MILITARY SPECIFICATION
MICROCIRCUIT, DIGITAL, CMOS (FINAL LOGIC)

This amendment forms a part of Military Specification MIL-M-63321A(AR) dated 8 April 1981, and is approved for use by the US Army Armament Research and Development Command and is available for use by all the Departments and Agencies of the Department of Defense.

FIGURE 11. Burn-in and steady state of life test circuit.

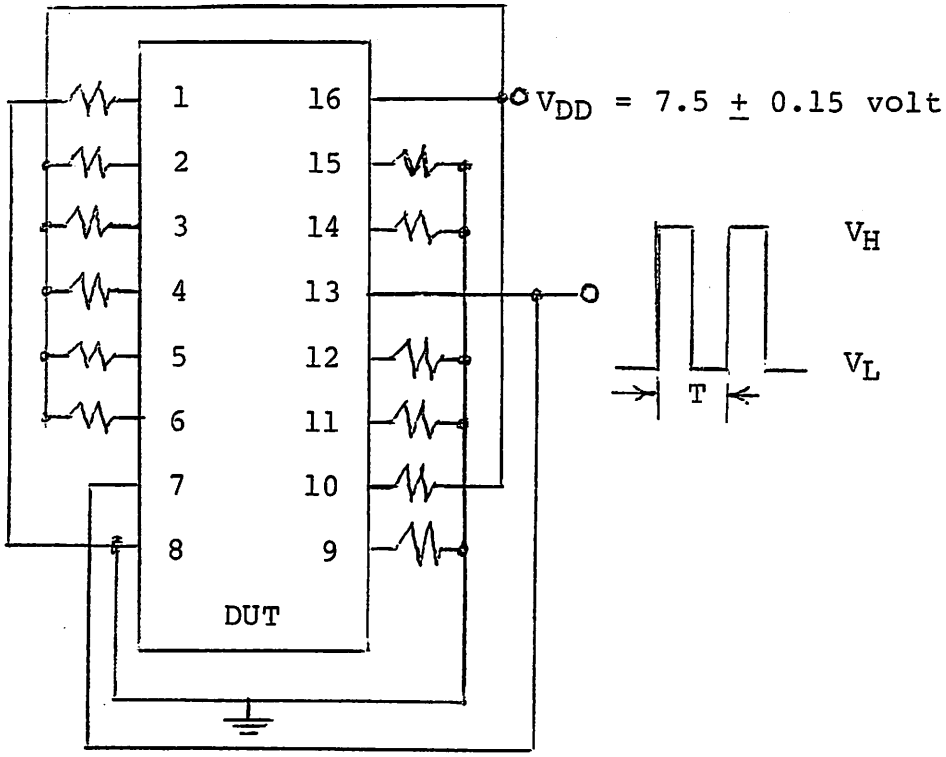
FIGURE 11: Delete present and substitute revised FIGURE 11 attached to this amendment.

V_H = 7.5 -.15 volts

V_L = 0.5 ± 0.15 volts

T = 40 ±4uS period, 50% duty factor.

All R(s) = 51K ohms max.
